## Swanzey Planning Board Meeting Agenda

## Memorandum – Office of Land Use

TO: Planning Board  
FROM: Stephon Mehu, Assistant Town Planner  
DATE: March 5, 2024  
RE: Planning Board #24-003 – Nucar Nissan of Keene SPR – 544 Monadnock Highway  
(Tax Map 222 Lot 34)

# NUCAR NISSAN OF KEENE

**NUCAR NISSAN OF KEENE**  
 SITE IMPROVEMENTS  
 SWANZEY, NEW HAMPSHIRE  
 PROPOSED SITE PLAN

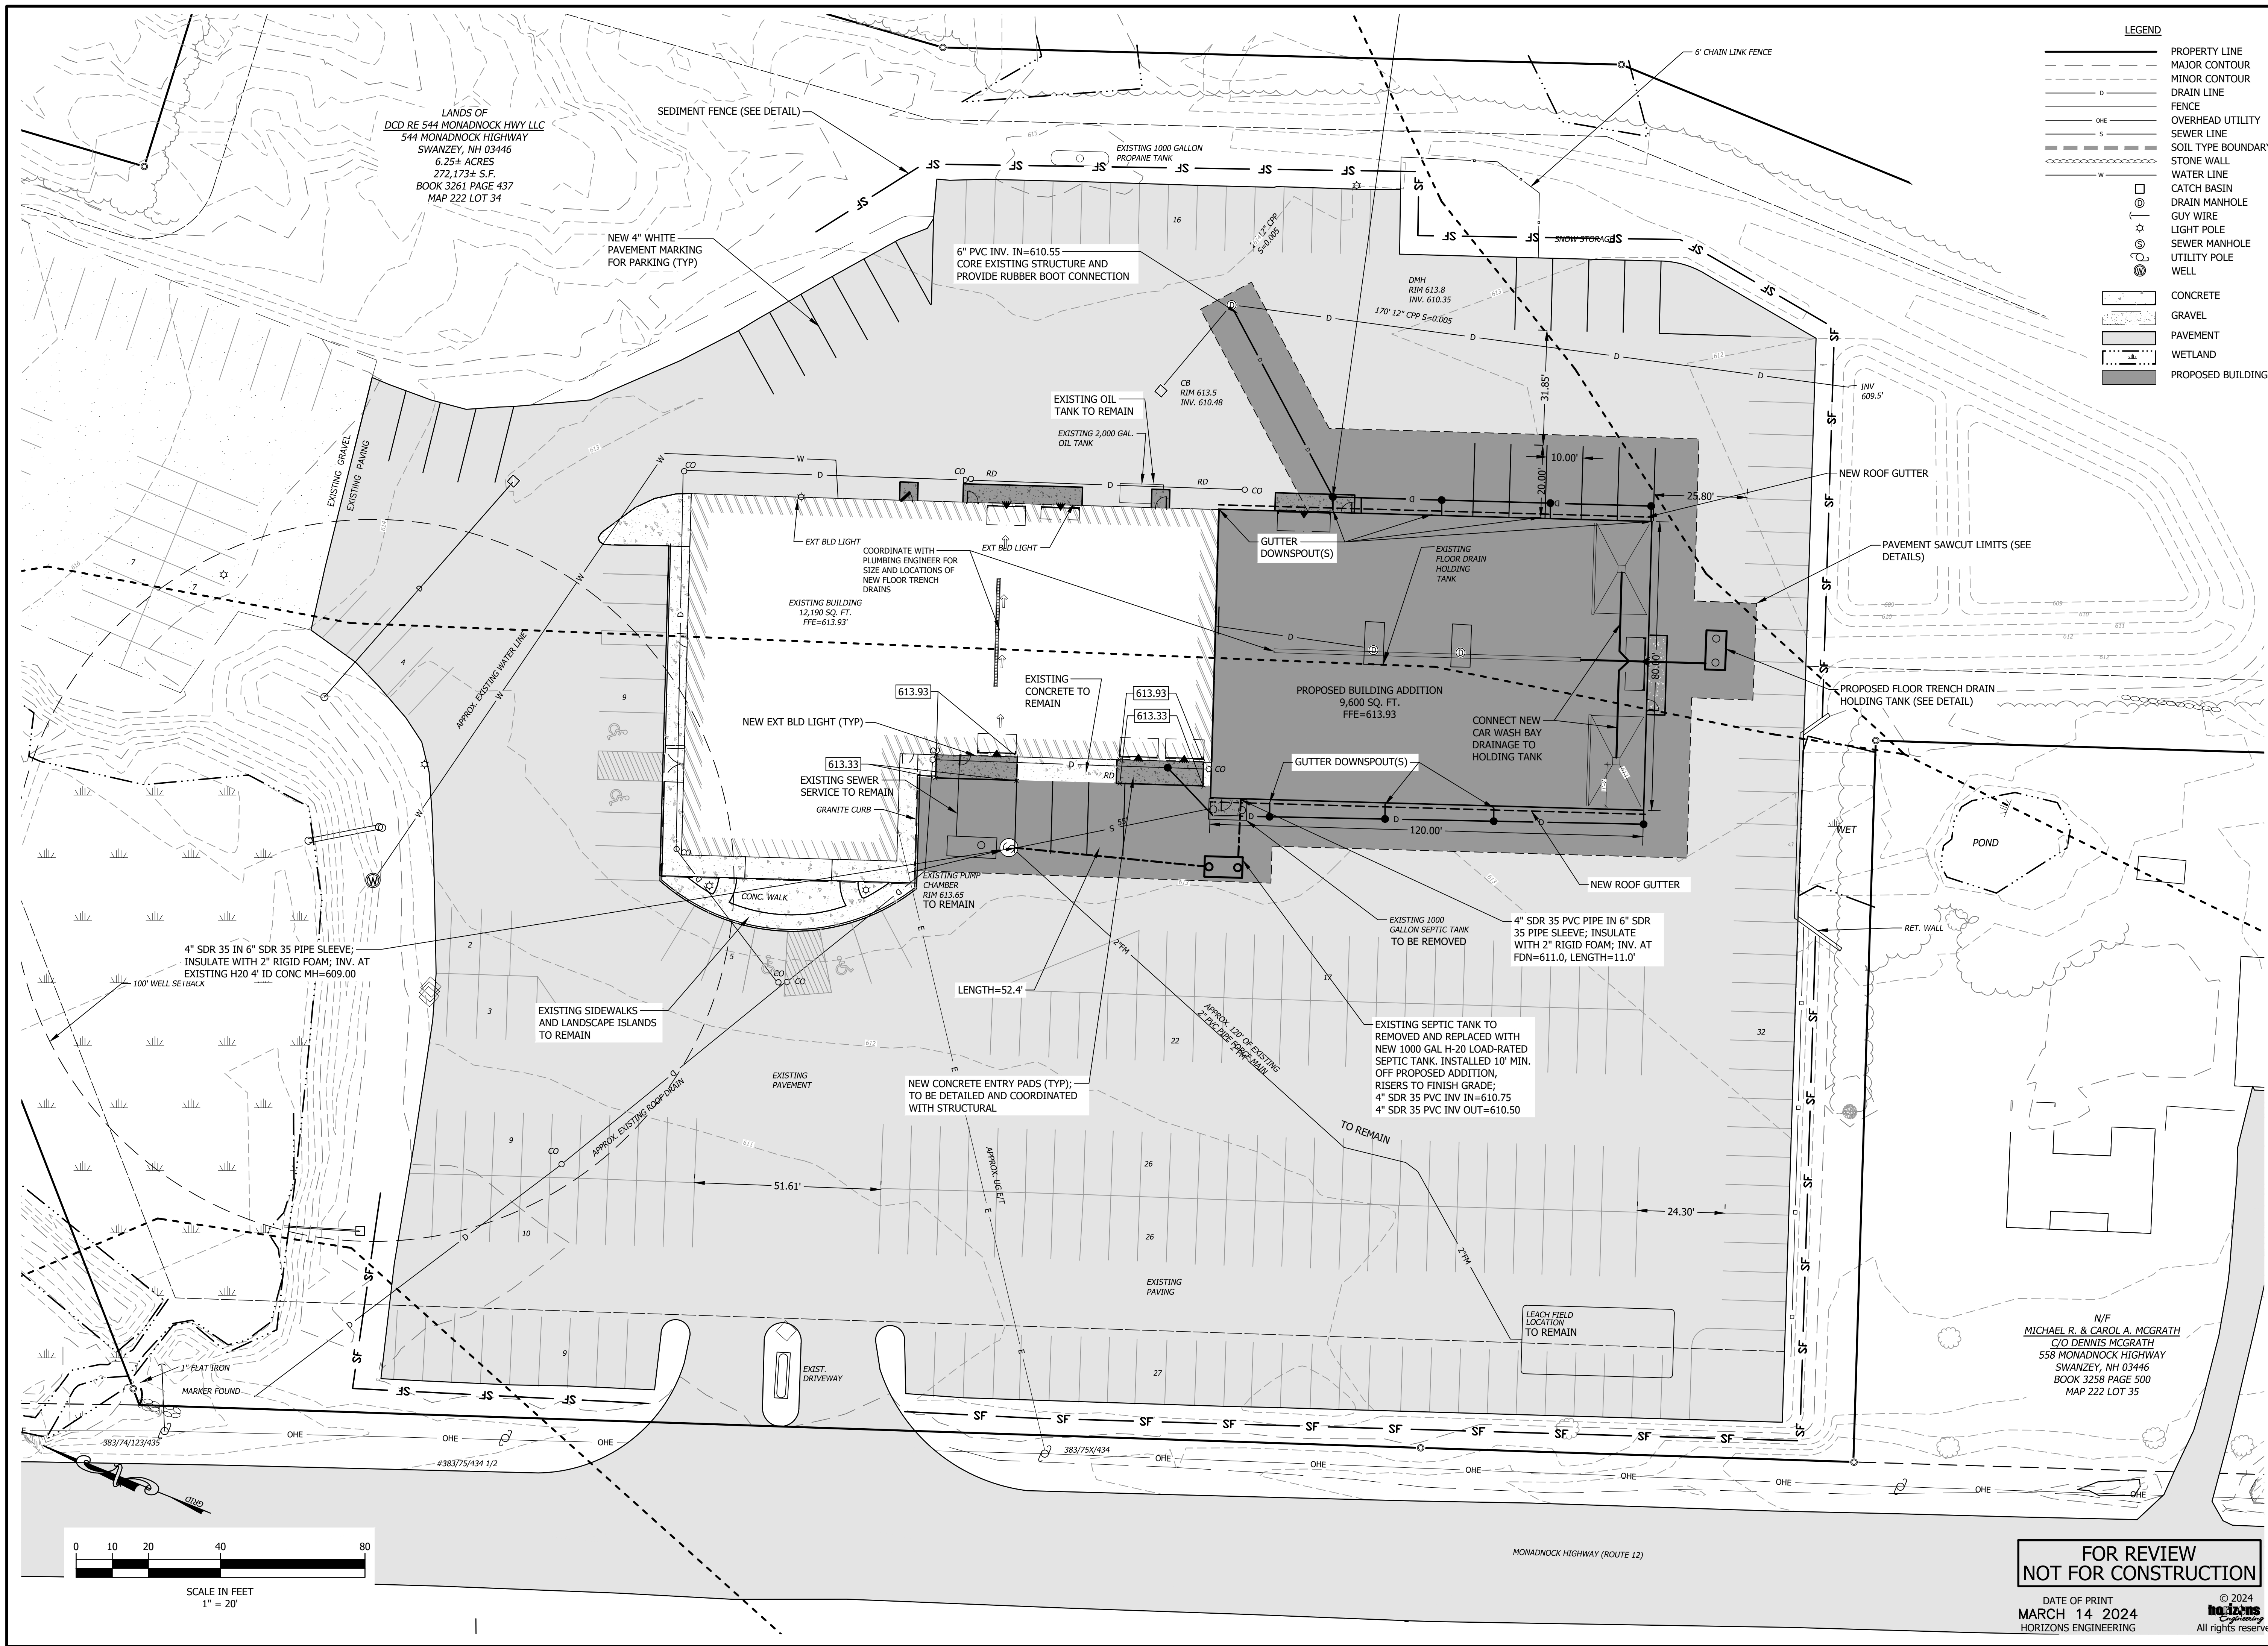
The subject property illustrates a topography indicative of surface water flowing to the west, towards Monadnock Highway and Map 222 Lot 33. Submitted plans identify 3 (three) catch basins, one being situated to the west corner of the lot, approximately twenty feet to the neighboring wetland. The additional catch basins have one located north of the existing building and the other located northeast of the existing building. No proposed drainage plan has been provided.

The increase in the peak flow of surface runoff as a result of the development is not permitted to pass beyond the property lines. No grading and drainage plan is present.

Storm water from the proposed buildings and parking area is directed to existing catch basins on the site, however, a storm water chamber infiltration system was not identified.

1. Horn and strobe fire protection system on proposed buildings
2. Identification of bulk fuel storage and capacities on plans
3. Details regarding destination and use of contents of holding tanks for addition
4. Distribution and management plan for storm water
5. Labeling of scale of site plan pages required
6. All local permits as required
